PROJECT: North Castle NY - JG Petrucci DATE: 7/12/2021
 2179-99-009
 SUBJECT: 94 Business Park Drive TRANSMITTAL ID: 00006
 PURPOSE: For your use VIA: Info Exchange

**RE: Armonk Fairview, LLC &
Aggro and Brassi, LLC
Proposed Warehouse
Section 108.03; Block 1; Lot 50
94 Business Park Drive
Town of North Castle (Armonk)
Westchester County, NY
DEC #2179-99-009**

The following are responses to an engineering review letter prepared by Kellard Sessions dated March 5, 2021:

TITLE: **SITE PLAN**

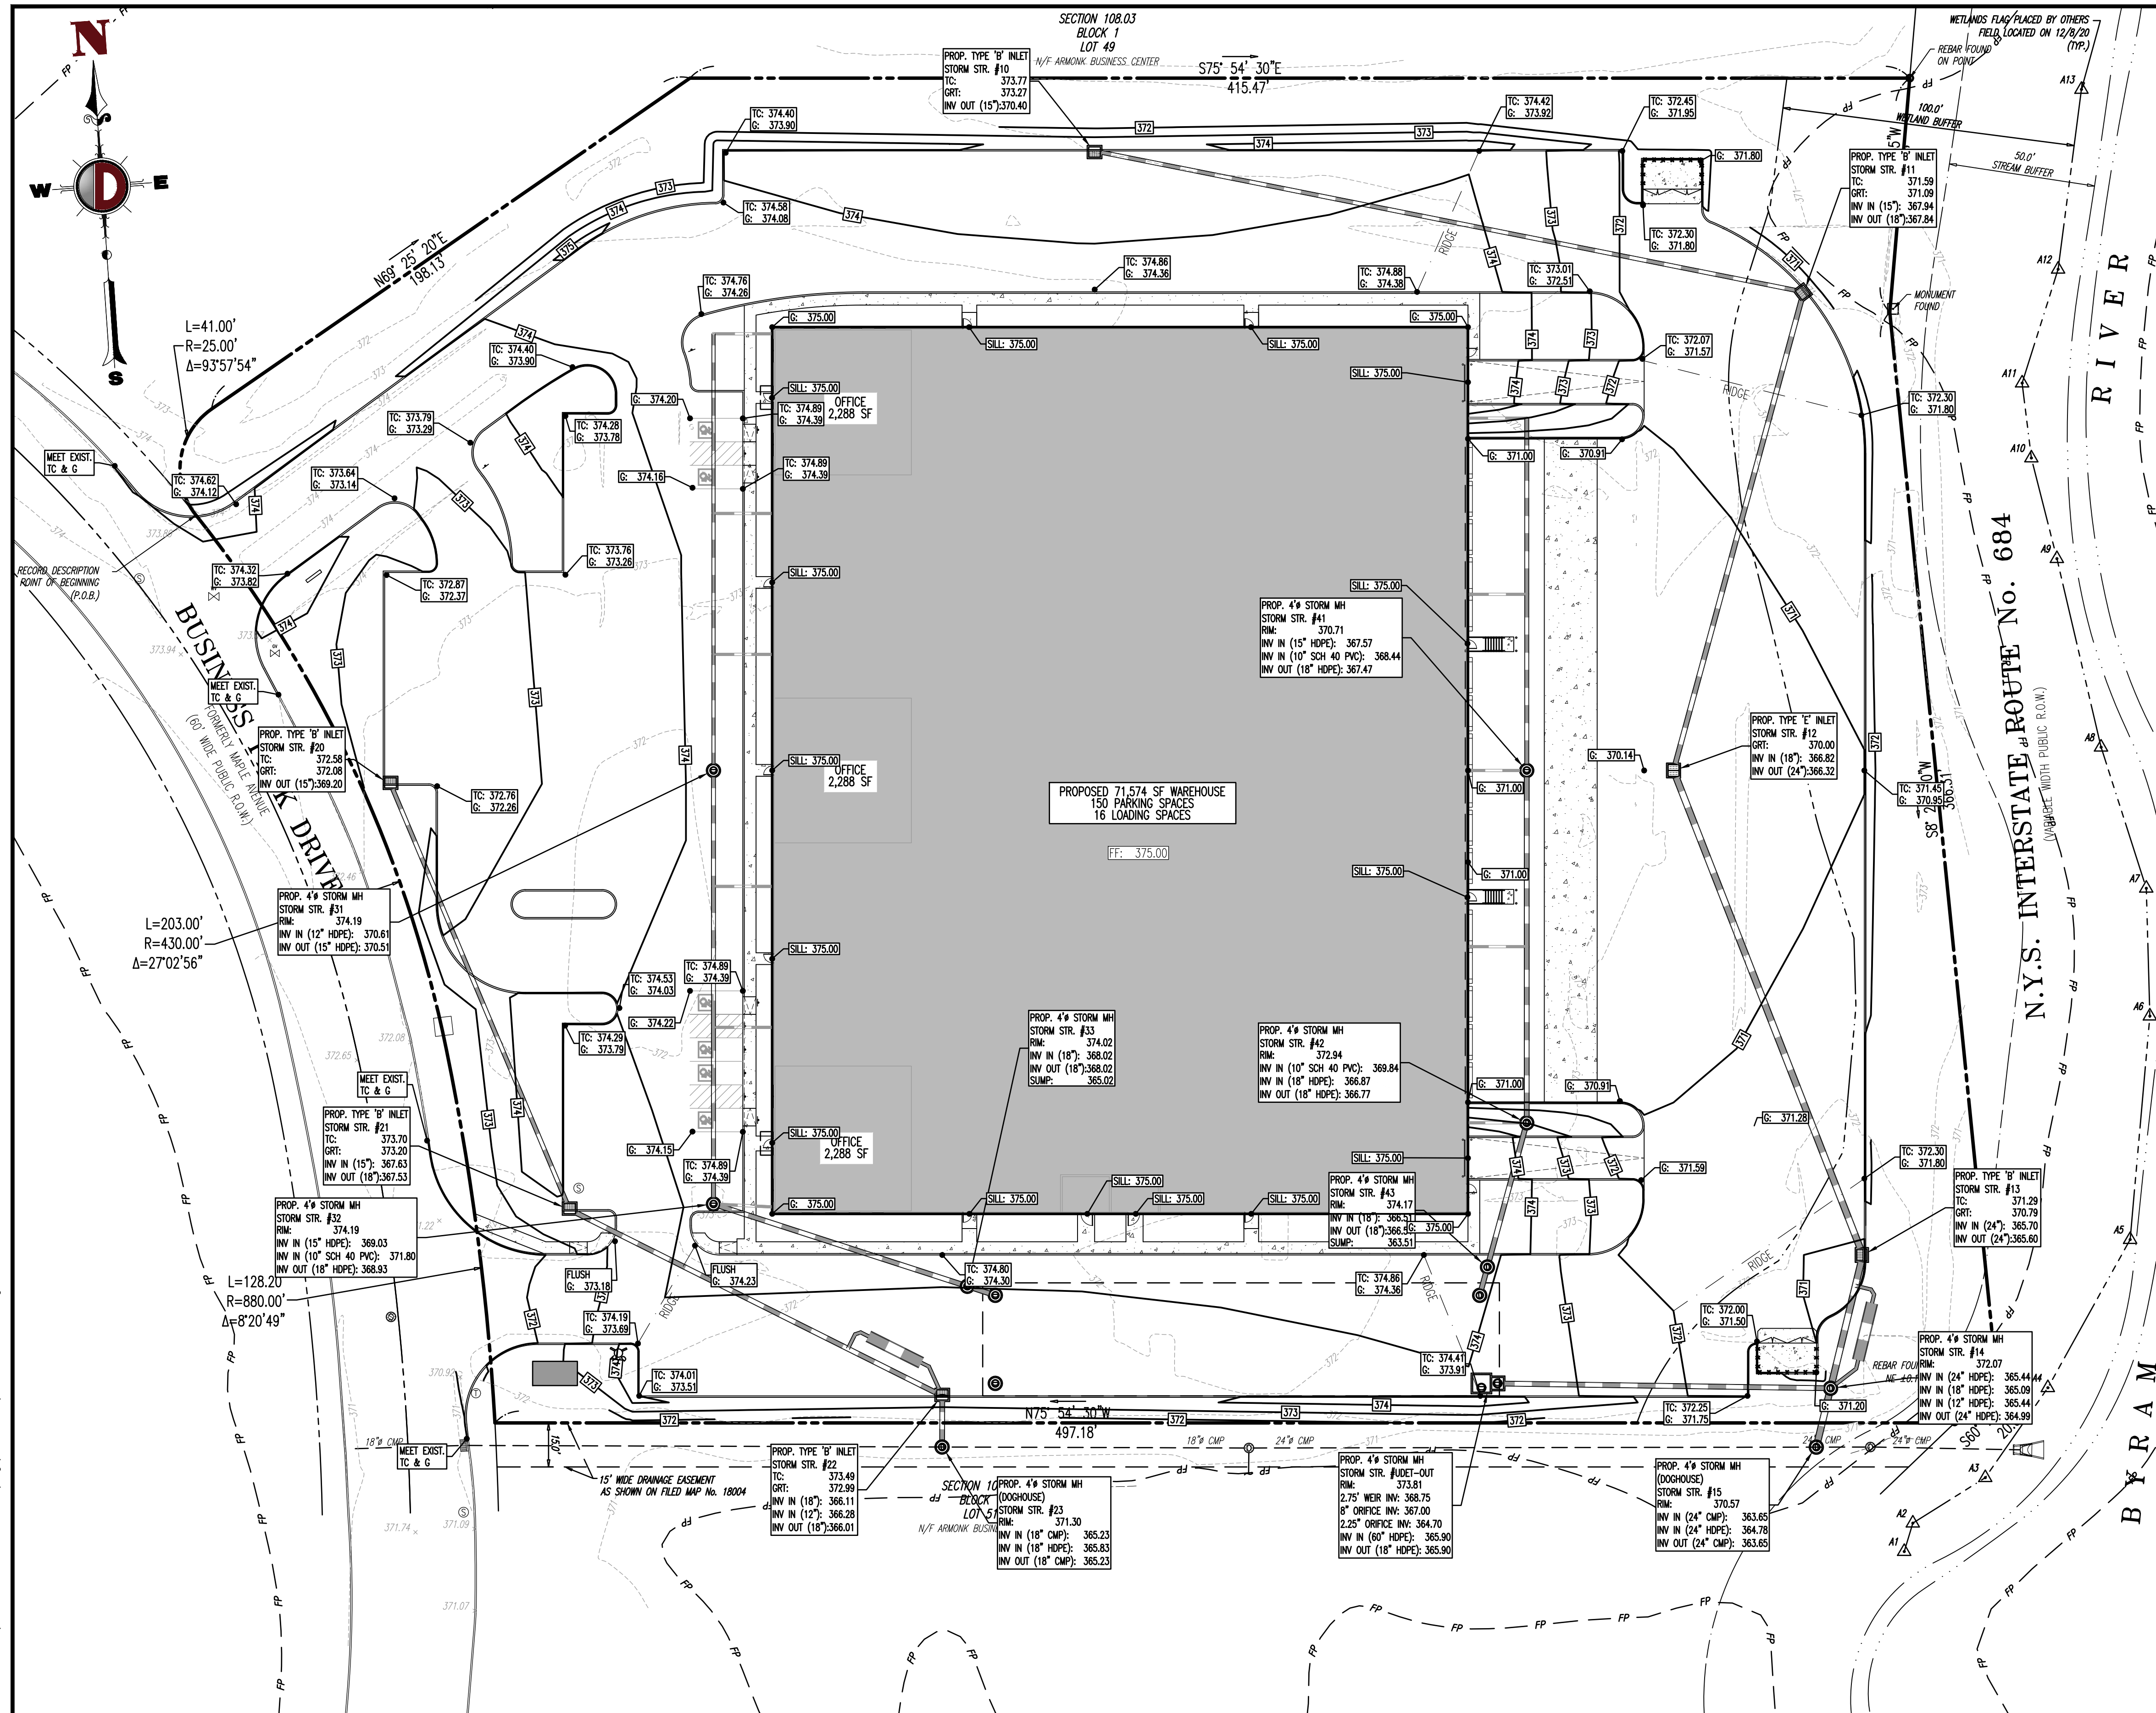
10. The plan proposes a total of 150 parking spaces, including six (6) accessible parking spaces, as required by Section 355-56N (1) of the Town Code. For clarity, Site Plan Note No. 8C should be corrected to indicate this as well.

Site Plan Note No. 8C has been revised as required.
